Technical Service Bulletin

SUBJECT:		No:	TSB-19-11-003
UPDATES TO OIL PAN & TIMING CHAIN CASE REMOVAL & INSTALLATION PROCEDURE - SMR		DATE:	July 2019
		MODEL:	2014-16 Outlander
CIRCULATE TO:	<input type="checkbox"/> GENERAL MANAGER	<input type="checkbox"/> PARTS MANAGER	<input checked="" type="checkbox"/> TECHNICIAN
<input checked="" type="checkbox"/> SERVICE ADVISOR	<input checked="" type="checkbox"/> SERVICE MANAGER	<input checked="" type="checkbox"/> WARRANTY PROCESSOR	<input type="checkbox"/> SALES MANAGER

This TSB updates the Engine Section of the affected Service Manuals, to revise the oil pan and timing chain case removal and installation procedure.

AKB00153AE

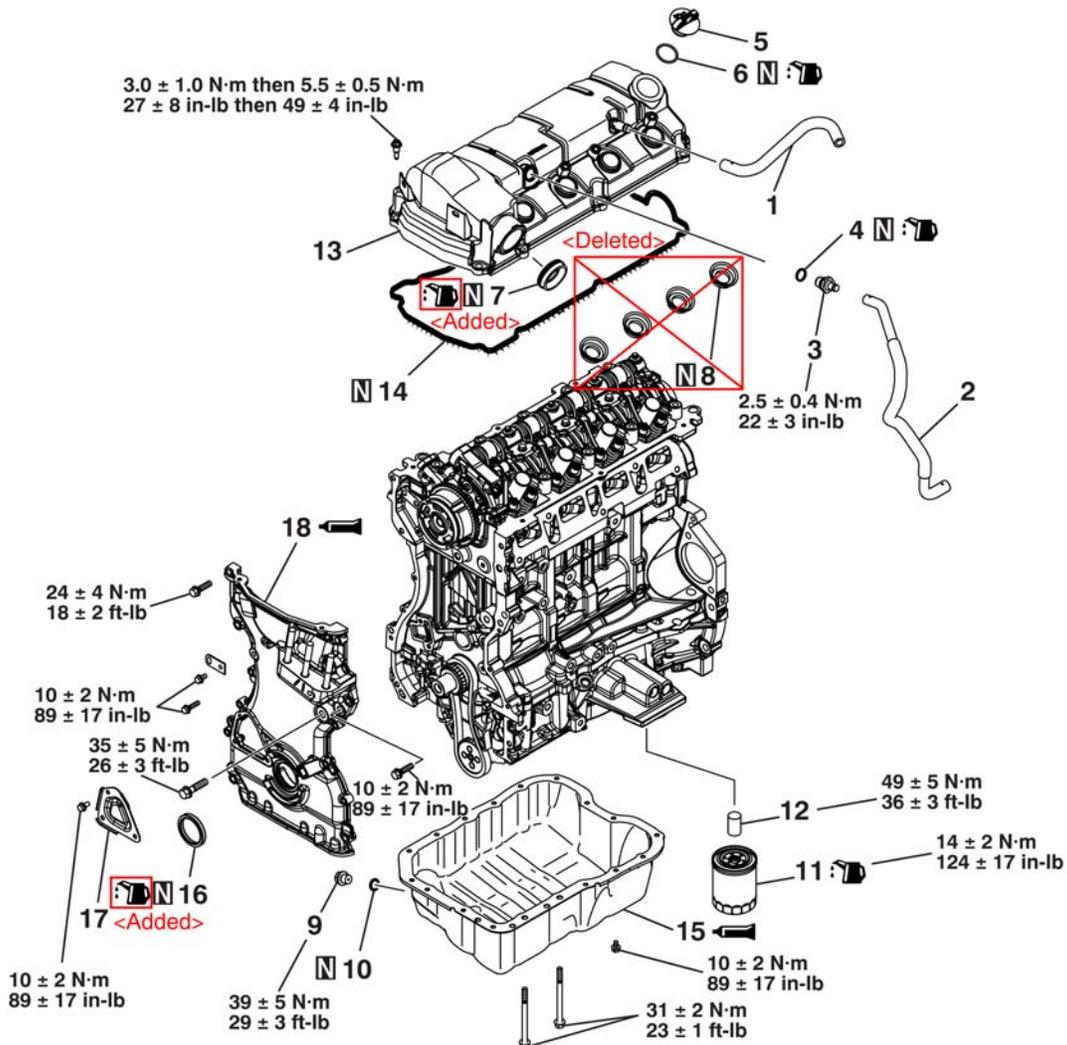
Please make the indicated changes to the 2014 - 2016 Outlander Service Manual, Group 11-Engine
 -> 11B-Engine Overhaul <2.4L Engine> -> Oil Pan and Timing Chain Case.

1. Breather hose
 2. PCV hose
 3. PCV valve
 4. PCV valve gasket
 5. Oil filler cap
 6. O-ring
 7. Oil seal
 - ~~8. Oil seal~~
 9. Oil drain plug
- <A>> >>G<<
 <Deleted>
